ILLINOIS POWER COMPANY

CLINTON POWER STATION, P.O. BOX 678, CLINTON, ILLINOIS 61727

Subject: Clinton Power Station Unit 1  
SER Issues - Pool Dynamics  
Outstanding #9/Confirmatory #13

Figure 1 - SRV Discharge Line Support - Welded Attachment Detail

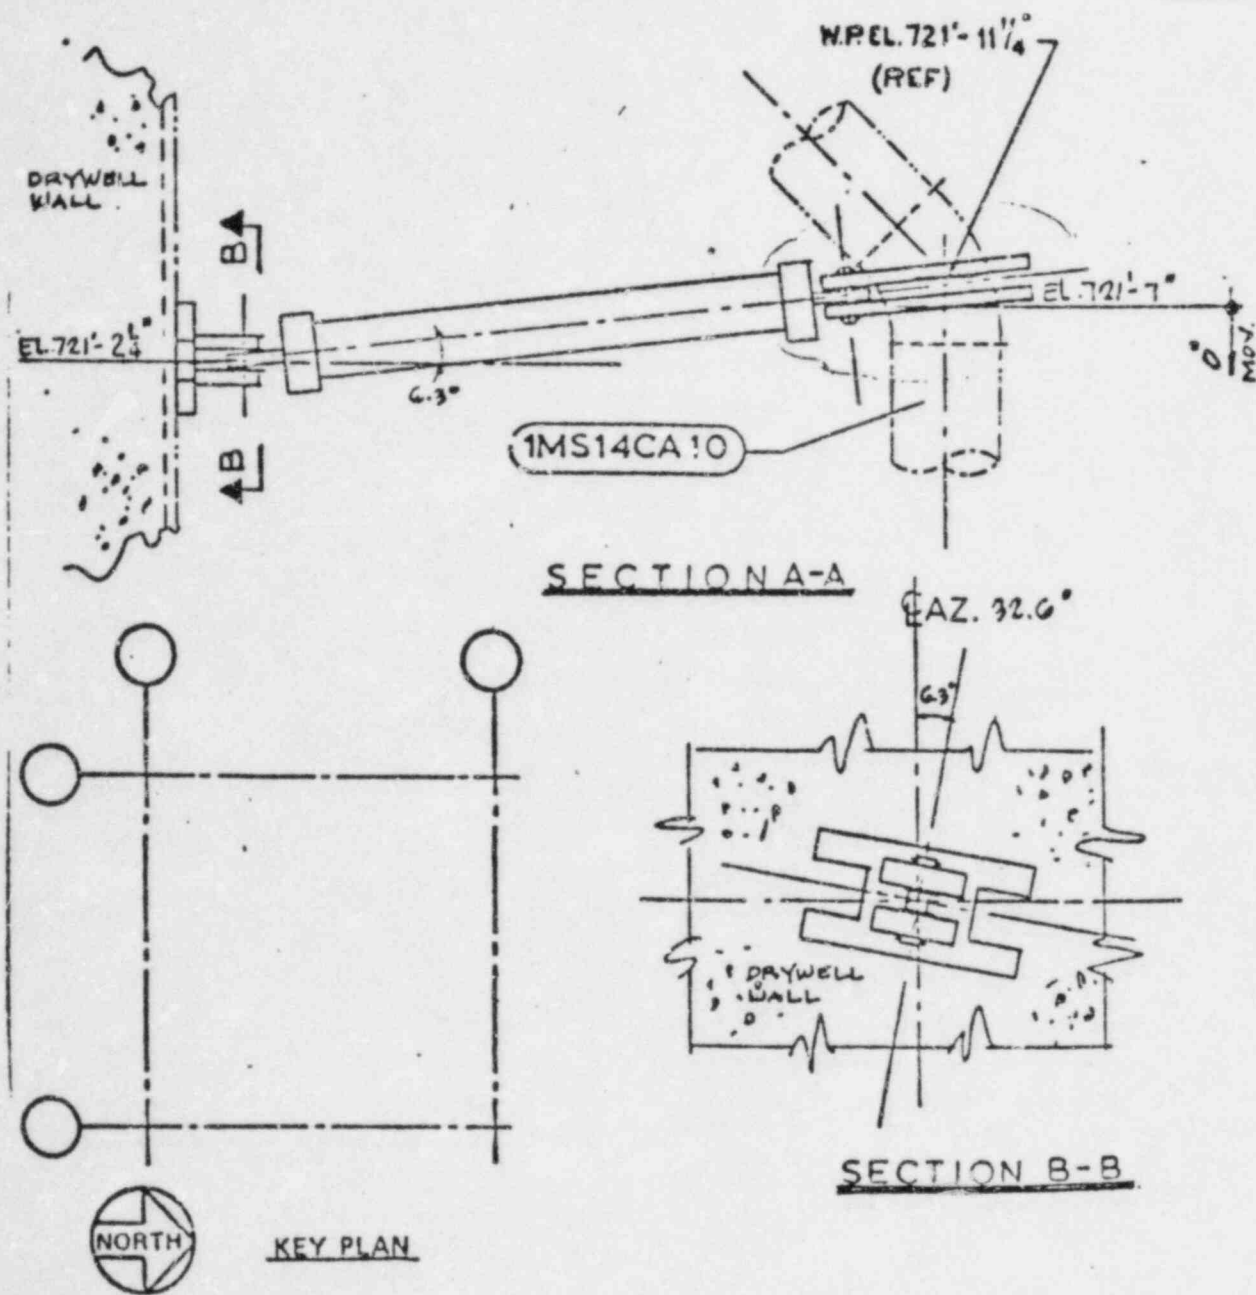
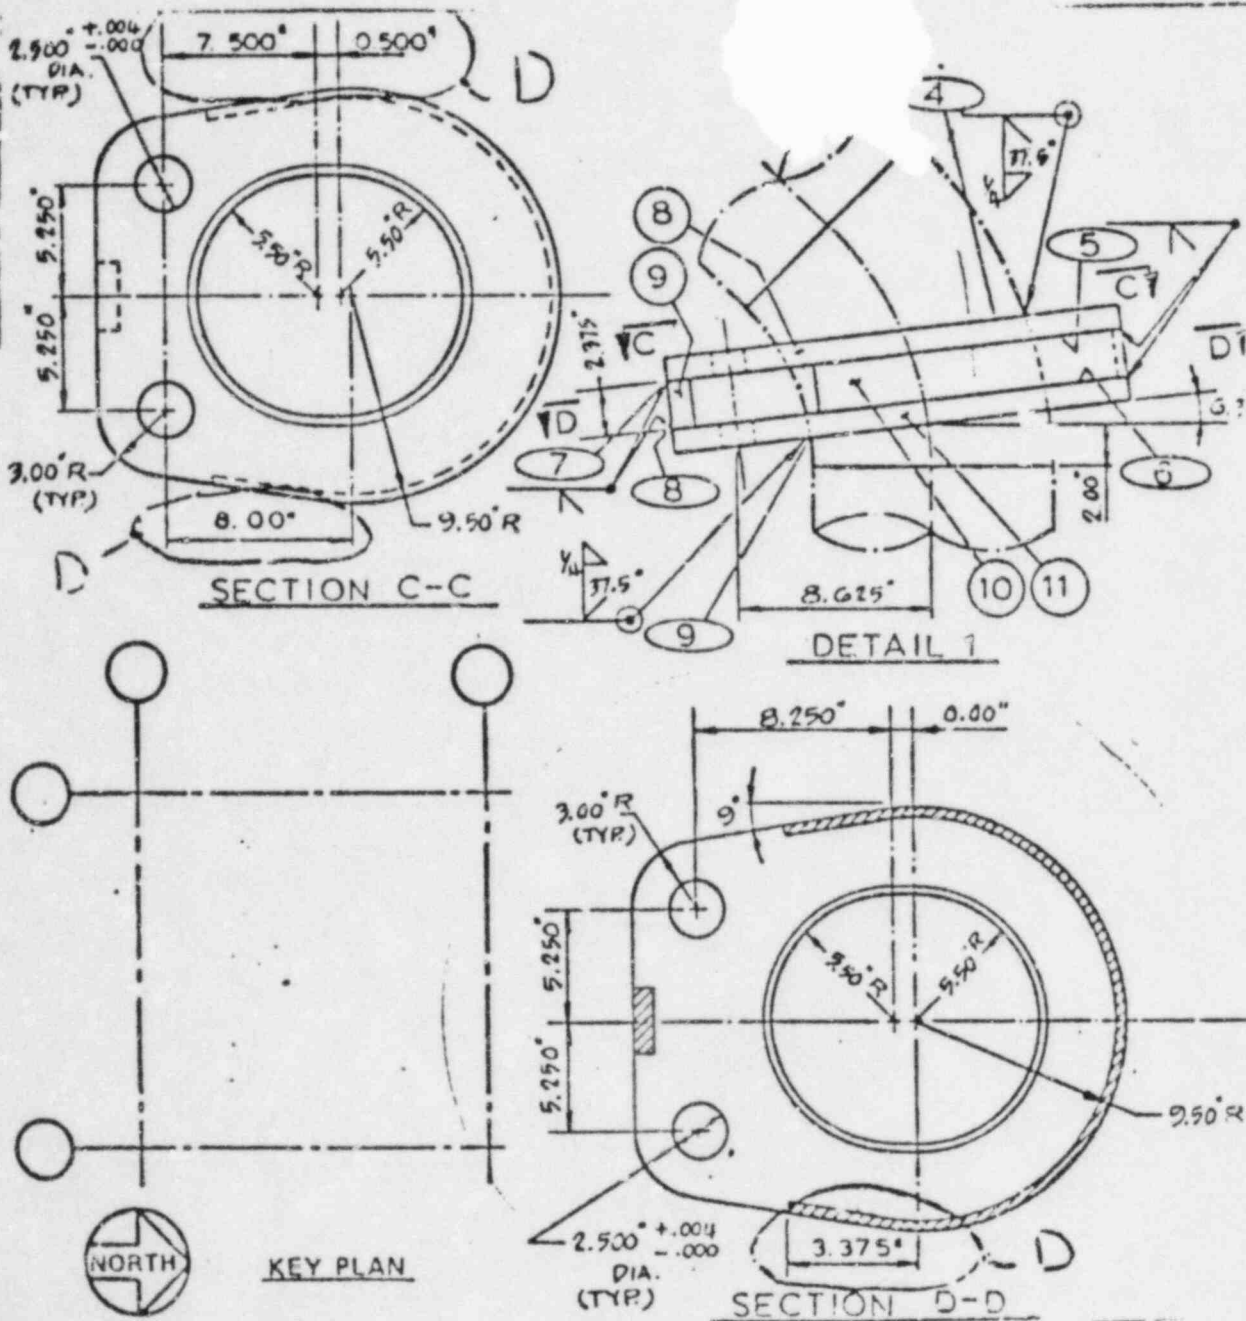
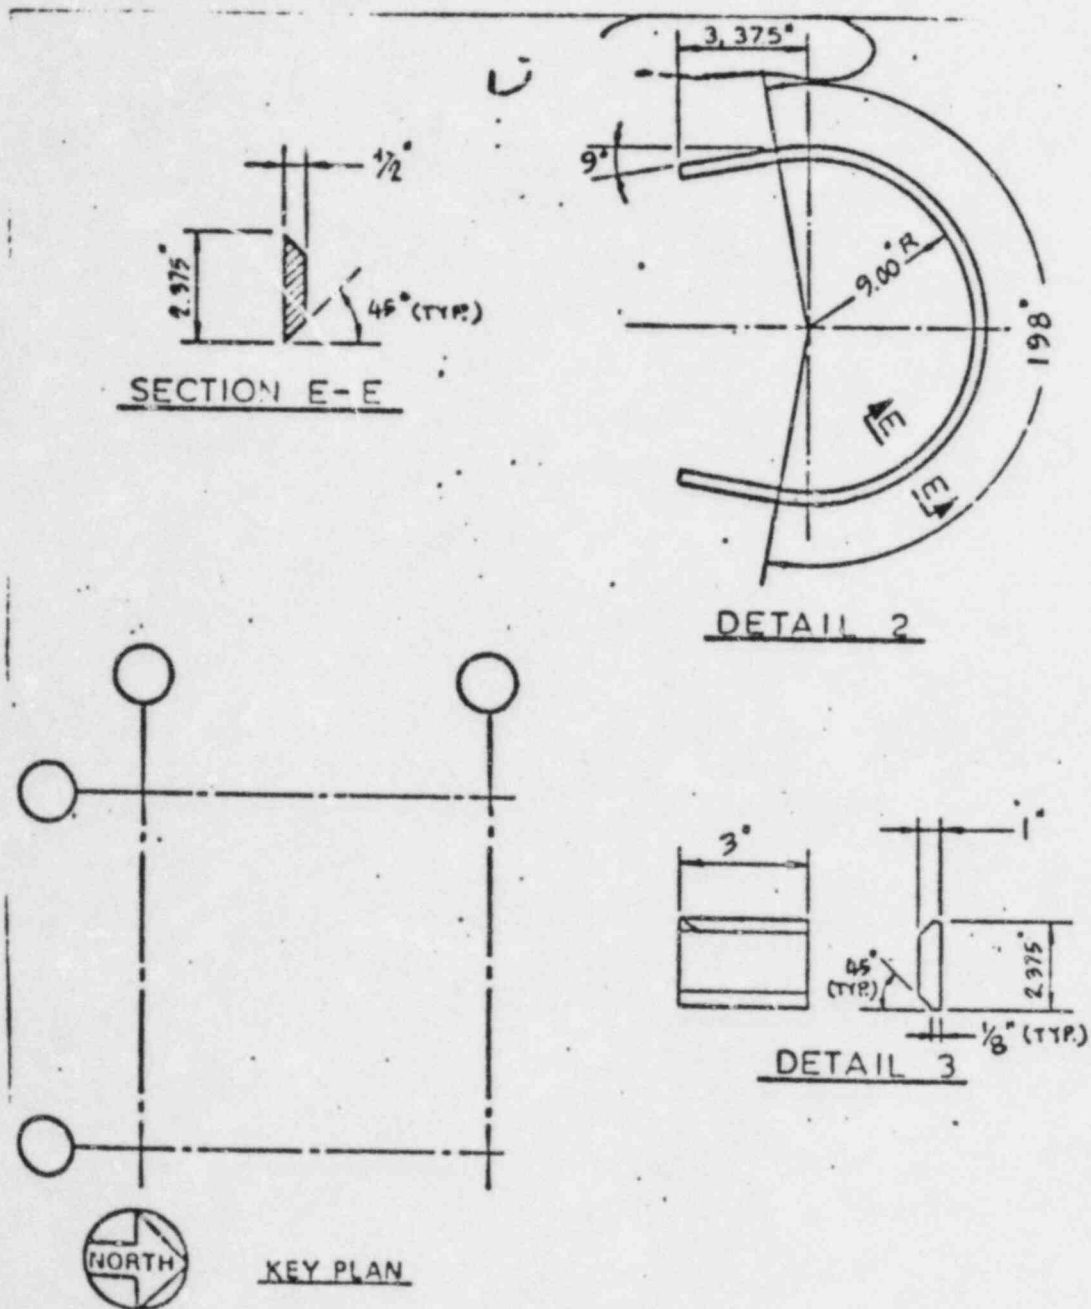
In a comparison of the quencher and support per NUREG-0763, you have shown that the quencher base support is welded to the basemat and is provided with rigid supports from the SRV discharge line to the drywell wall. It is not clear whether the rigid supports are welded directly to the SRV pipe or to a collar around the pipe. In the staff's opinion, if the supports are welded directly to the SRV pipe, the welded attachment could cause excessive localized bending stresses and potentially harmful thermal gradients in the piping following actuations of the safety-relief valves. Furthermore, the large number of stress cycles could result in fatigue failure in the piping. Provide the quencher support details and the results of your stress analyses for the SRV piping at the support attachment. Provide assurance that the structural integrity of the piping and the quencher support capabilities are not compromised.

Each of the 16 SRV discharge lines is rigidly restrained to the drywell wall by a support connected immediately above the quencher inlet. This support consists of a collar-type attachment welded to the piping, as shown in Figure 210.01-1. As per Code Subsection ND requirements, localized bending stresses due to mechanical and thermal expansion loading have been considered for the piping at the attachment location. As shown in Table 210.01-1, an envelope of finite element analyses of these connections has been generated. The local stresses from the attachments were added to the pipes' nominal bending and pressure stresses. A summary of maximum pipe stresses is shown in Table 210.01-1.

As shown in Table 210.01-1, there is a large margin for Equation 10 and 11 stresses. Although not required, thermal gradient stresses if added to Equations 10 and 11 would not create a fatigue problem. Also, a higher allowable stress for these equations could be justified per Code Case N-318, since the number of stress cycles would be less than 7000.

Therefore, per paragraph ND-3645 of the Code, these attachments to the SRV piping were conservatively designed and are well within ND-3650 stress allowables.

FIGURE #1

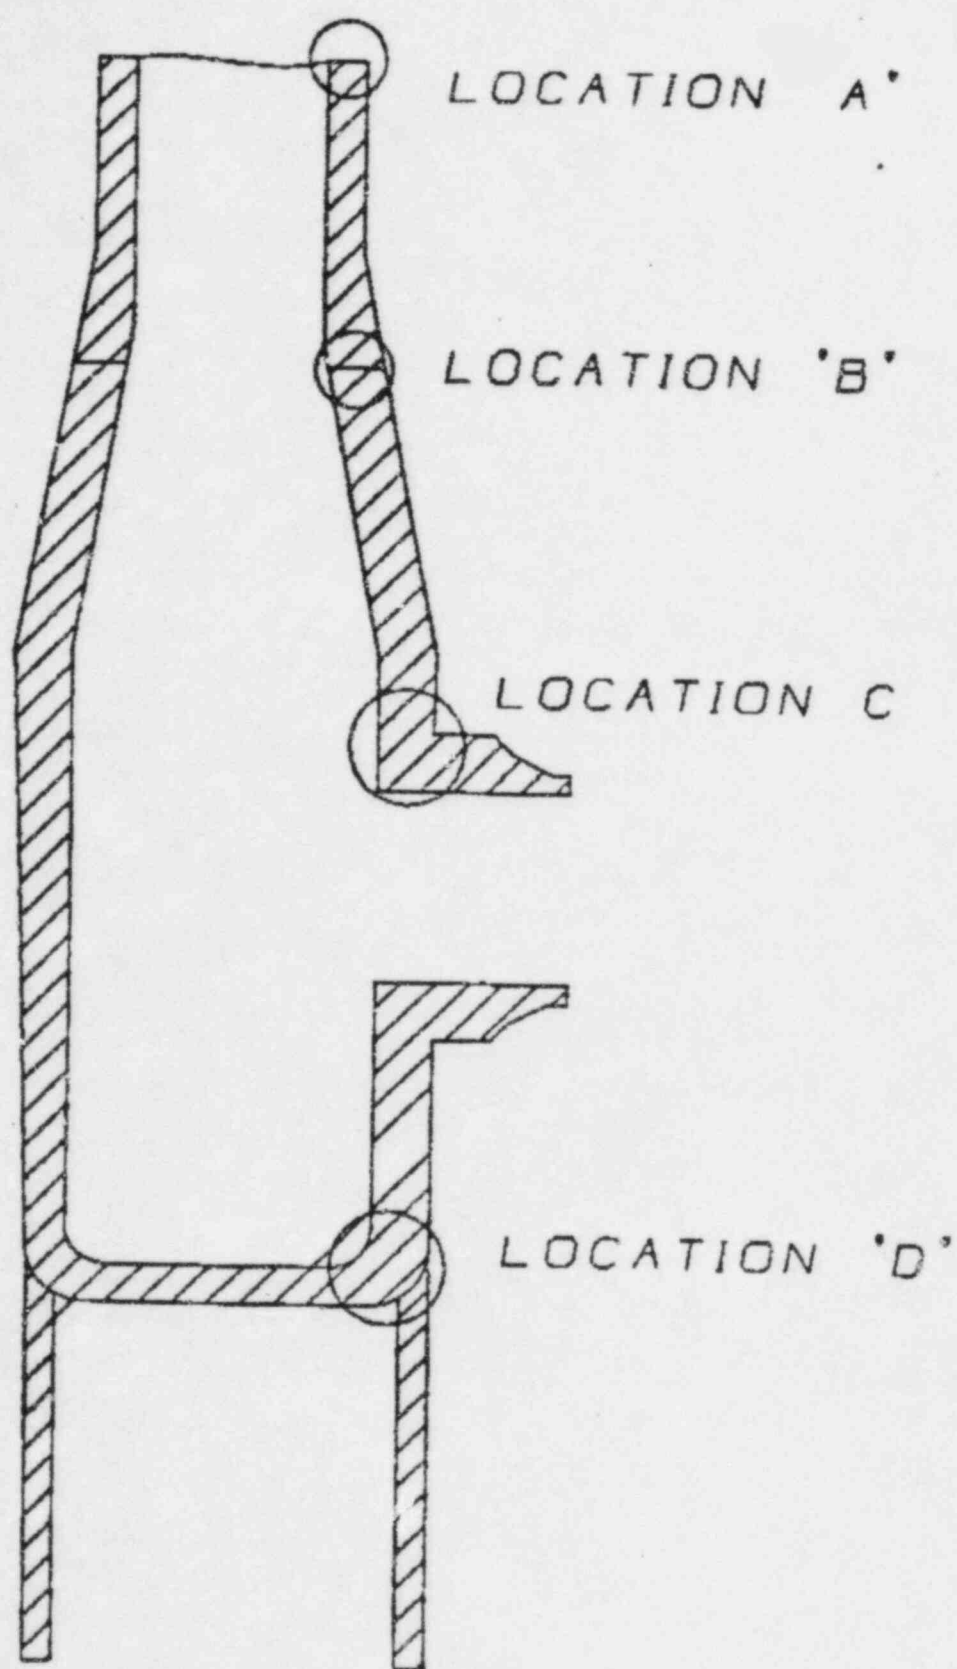
The quencher device is classified as an ASME Code Class 3 component. Provide the basis for assuring that the quencher device has been adequately designed for all applicable stresses resulting from the actuation of the safety-relief valves including localized bending stresses and thermal gradients.

General Electric Company analyzed four critical locations (shown on Figure 1 of Attachment 210.02) on the X-Quencher in order to assure that the quencher device meets the requirements of Subsection NB-3600 of ASME Code.

The four locations (designated as 'A', 'B', 'C' and 'D') represent the critical sections. Location 'A' is the SRV piping - quencher interface point and was selected because it is a dissimilar metal connection. Location 'B' is the X-Quencher adapter - reducer interface connection. Location 'C' is the quencher arm - body interface connection and location 'D' is the quencher connection to the pedestal adaptor. Fatigue usage factor was calculated for these locations using peak stress ' $S_p$ ' and alternating stress ' $S_a$ ' obtained from Equations 11 and 14 of Subsection NB-3600 respectively. To calculate the worst thermal gradients across these sections, the most severe transient was used. The transient consists of a step change from 70°F to 350°F. Appropriate heat transfer coefficients were calculated and applied for the transient. The stresses due to these thermal gradients were combined with the stresses due to the moment loading at these locations and the pressure stress. Secondary stress indices  $C_1$ ,  $C_2$  and  $C_3$  and local stress indices  $K_1$ ,  $K_2$  and  $K_3$  were calculated and applied for these locations based on their configurations.

Since the usage factors for the four critical sections are less than 1.0, we can safely conclude that the Clinton X-Quencher can withstand all normal and upset condition loads including the stresses due to thermal gradient and local bending effects.

Figure 480. 27-2-1

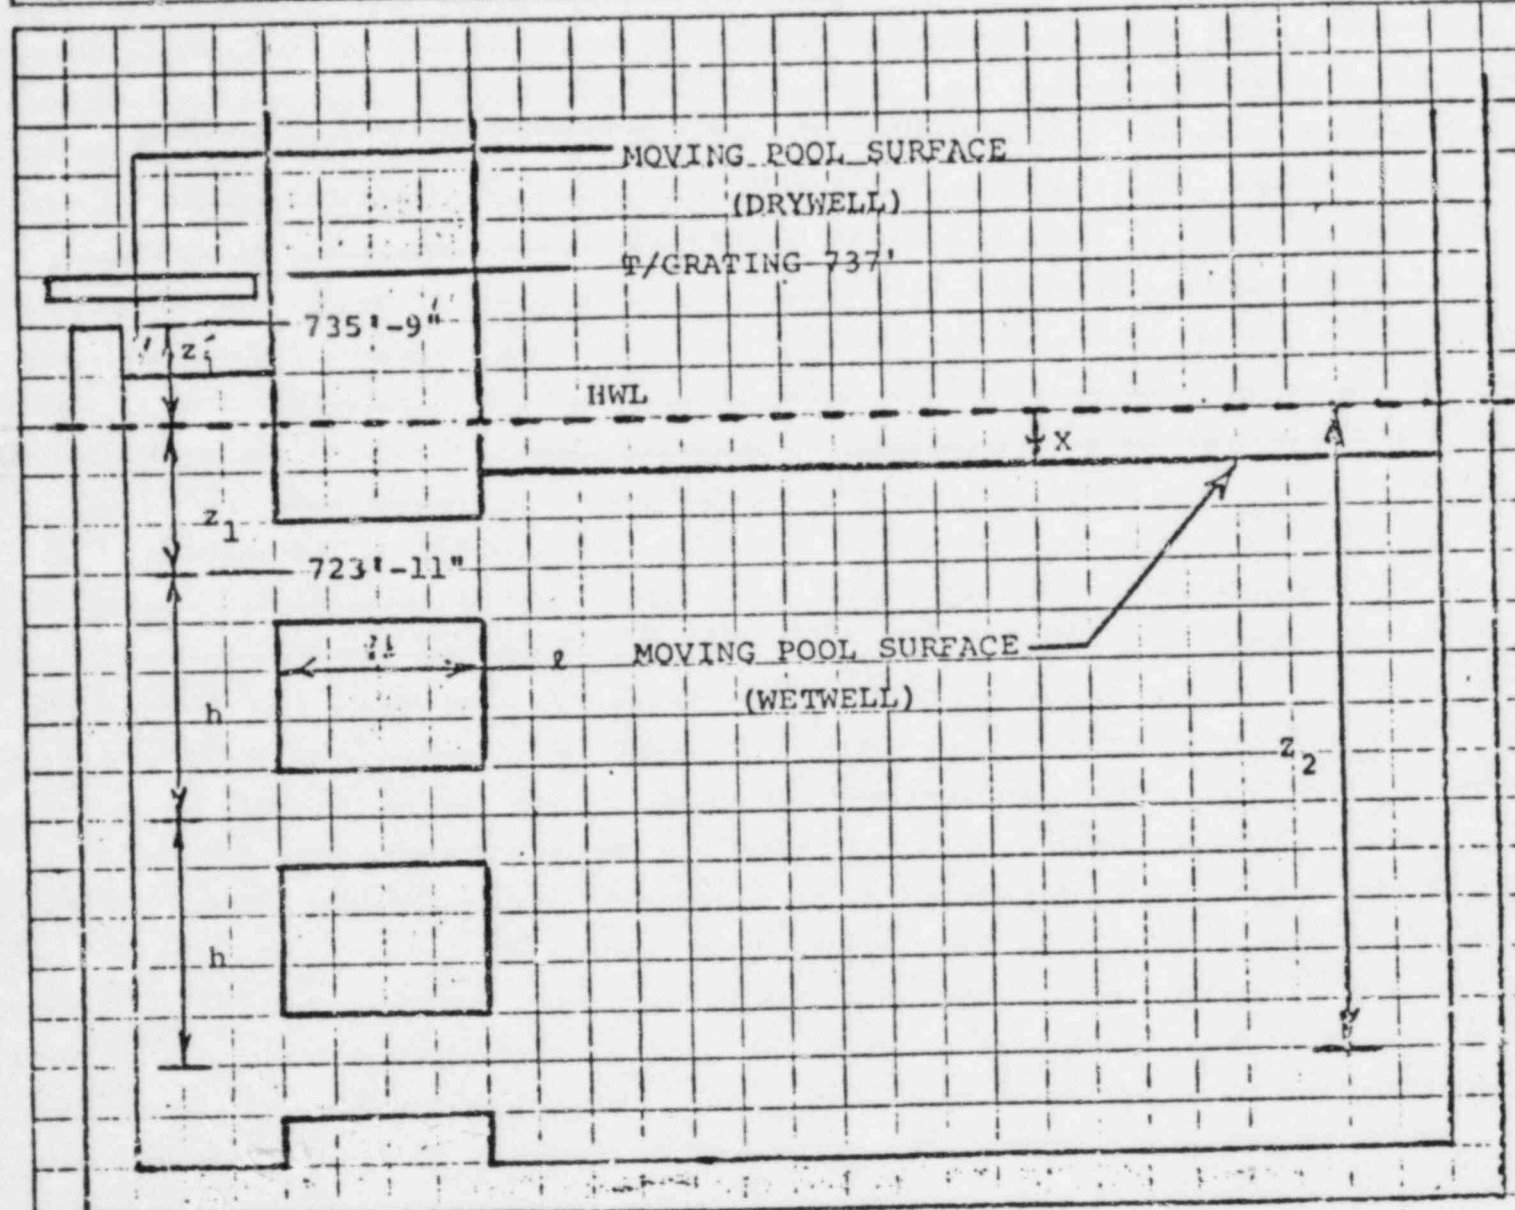
- 2) Provide and justify the load definitions used for structures and equipment that are beyond the scope of the generic load envelope contained in GESSAR-II (e.g., pipes within 0.25 feet of the top of the weir wall, submerged structures in the path of the horizontal vent water jets, and structures in the bulk pool region less than 4 feet long and/or closer than 6 feet from the initial pool surface).

Conservation of mass and energy were used to derive the equation of motion for weir annulus and vent flow. Figure 480.27-2-1 is a
